MIKKI ADDITION

WICHITA, SEDGWICK COUNTY, KANSAS

RE: S/D 99-24 -- Final Plat of MIKKI ADDITION

STAFF REPORT
(One-Step Final Plat Approved 4/8/99)

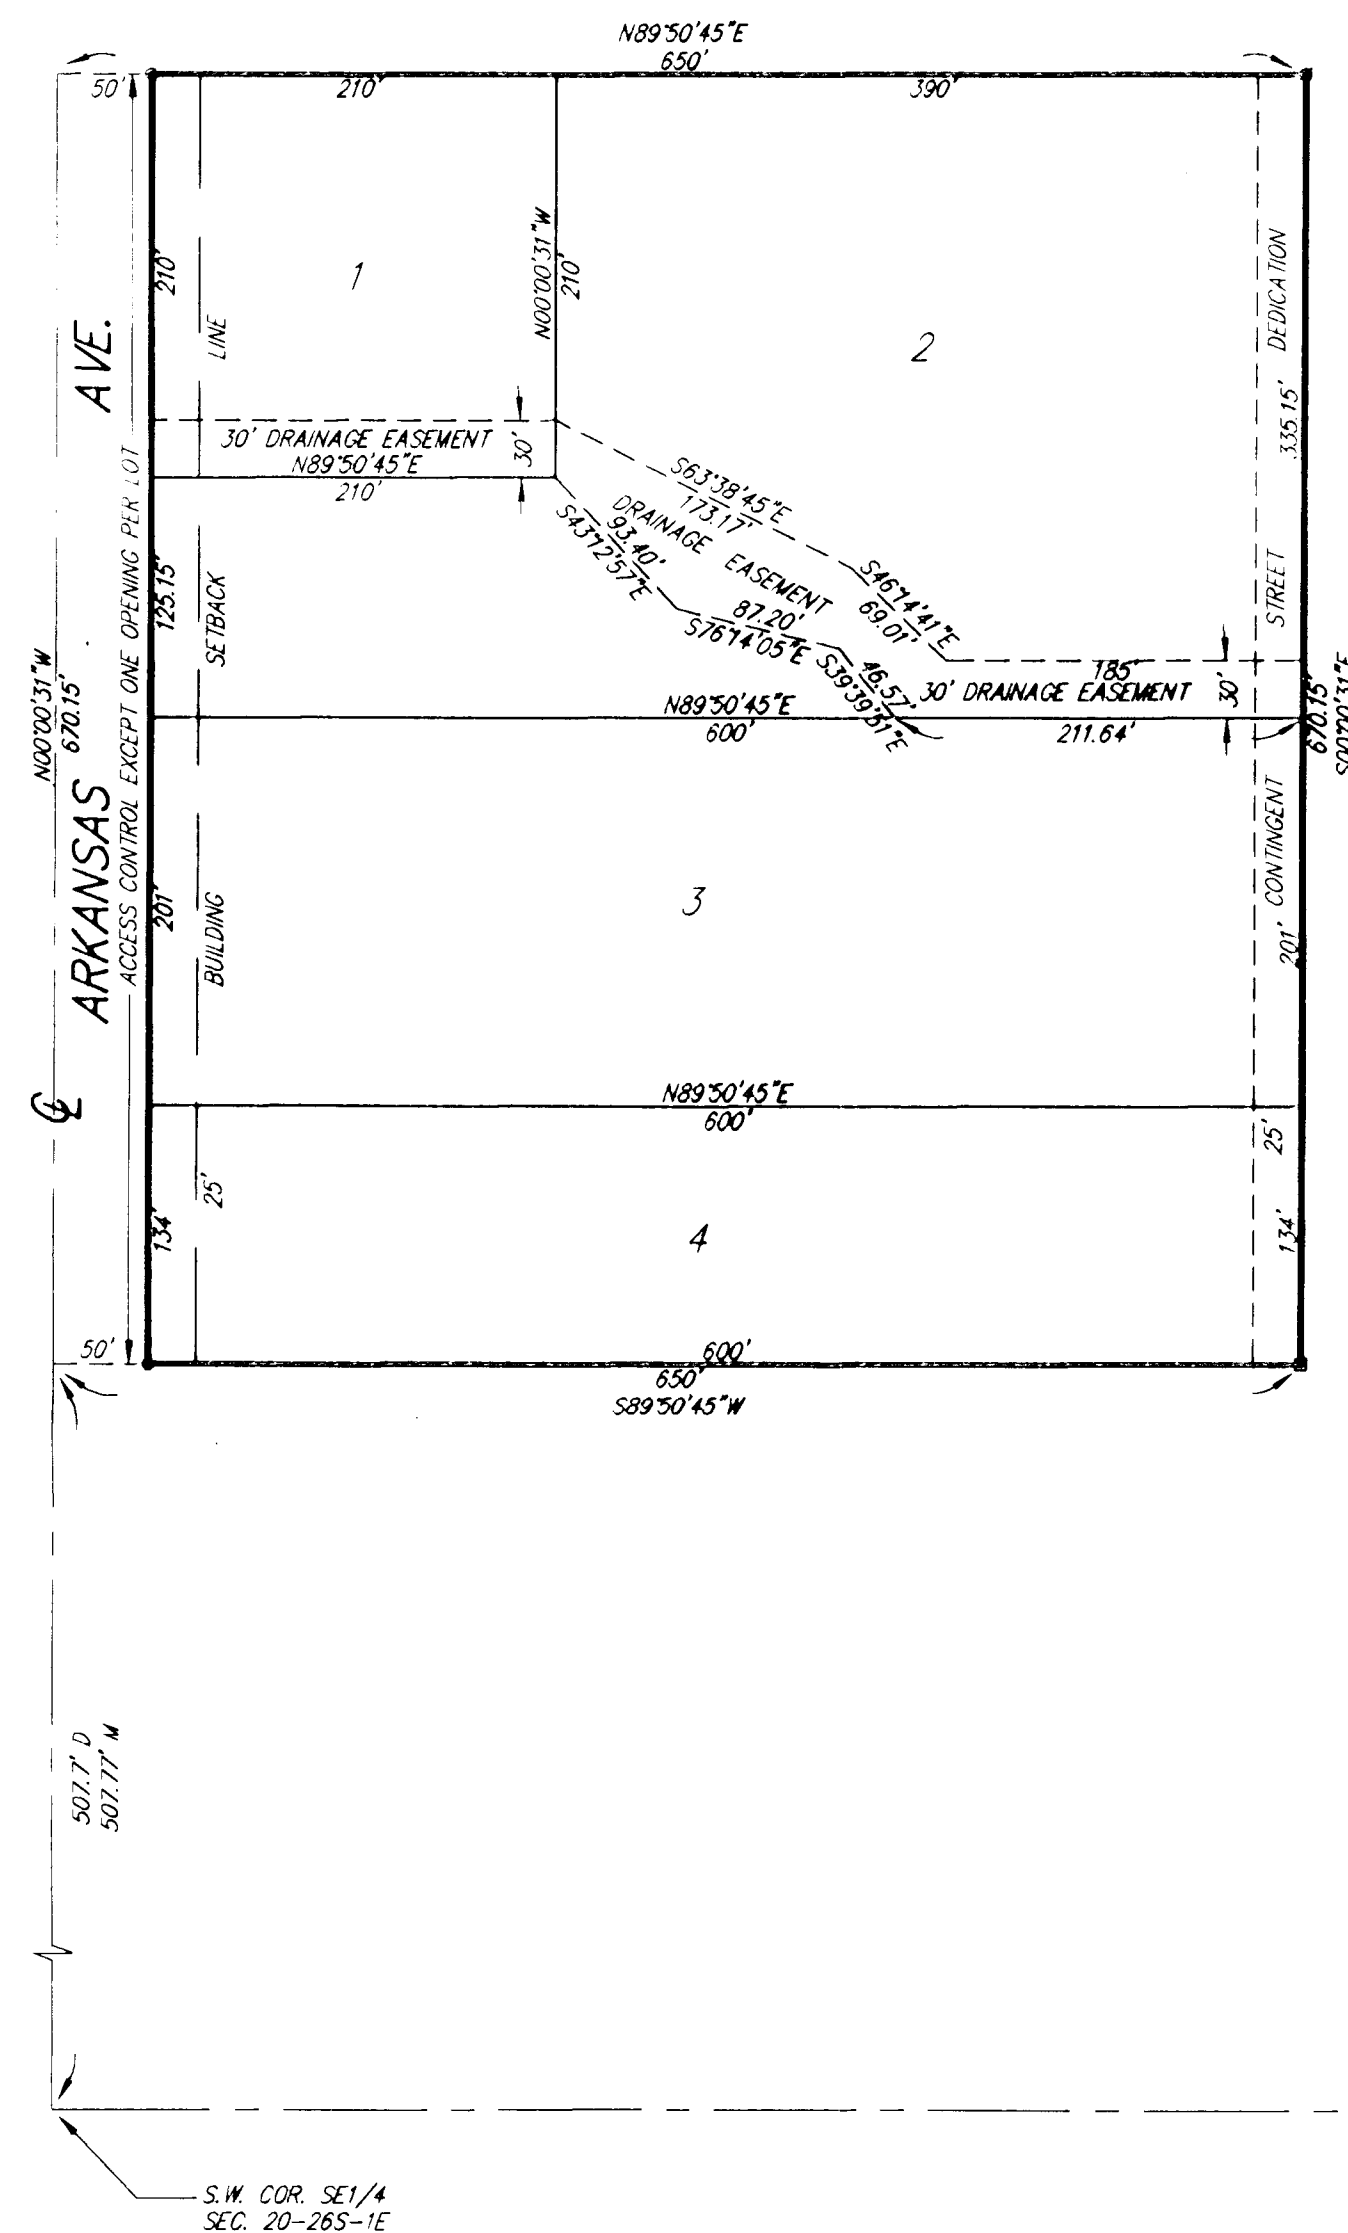
- D. City Engineering needs to comment on the status of the applicant's drainage plan. The drainage plan is approved. Minimum building elevations need to be denoted on the plat.

- E. Lots 2,3 and 4 exceed the lot depth to lot width ratio of 2.5 to 1, and a modification will need to be approved. City Fire requires the submission of a restrictive covenant limiting construction of a dwelling to be within 150 feet from the front property line; unless adequate access is provided by Waco.

- F. The plat denotes dedication of access controls except for one opening per lot along Arkansas Avenue. The plat's text needs to note the access controls are being dedicated to the City of Wichita.

- G. A contingent 25-ft street right-of-way dedication should be provided for the continuation of Waco along the east line of the plat.
- H. This property is within a zone identified by the City Engineers' office as likely to have groundwater at some or all times within 10 feet of the ground surface elevation. Building with specially engineered foundations or with the lowest floor opening above groundwater is recommended, and owners seeking building permits on this property will be similarly advised. More detailed information on recorded groundwater elevations in the vicinity of this property is available in the City Engineers' office.

- J. The platting text shall include language that a drainage plan has been developed for the plat and that all drainage easements, rights-of-way, or reserves shall remain at established grades or as modified with the approval of the applicable City or County Engineer, and unobstructed to allow for the conveyance of stormwater.

- F. The plat denotes dedication of access controls except for one opening per lot along Arkansas Avenue. The plat's text needs to note the access controls are being dedicated to the City of Wichita.

- G. A contingent 25-ft street right-of-way dedication should be provided for the continuation of Waco along the east line of the plat.
- H. This property is within a zone identified by the City Engineers' office as likely to have groundwater at some or all times within 10 feet of the ground surface elevation. Building with specially engineered foundations or with the lowest floor opening above groundwater is recommended, and owners seeking building permits on this property will be similarly advised. More detailed information on recorded groundwater elevations in the vicinity of this property is available in the City Engineers' office.

- J. The plat's text shall include language that a drainage plan has been developed for the plat and that all drainage easements, rights-of-way, or reserves shall remain at established grades or as modified with the approval of the applicable City or County Engineer, and unobstructed to allow for the conveyance of stormwater.
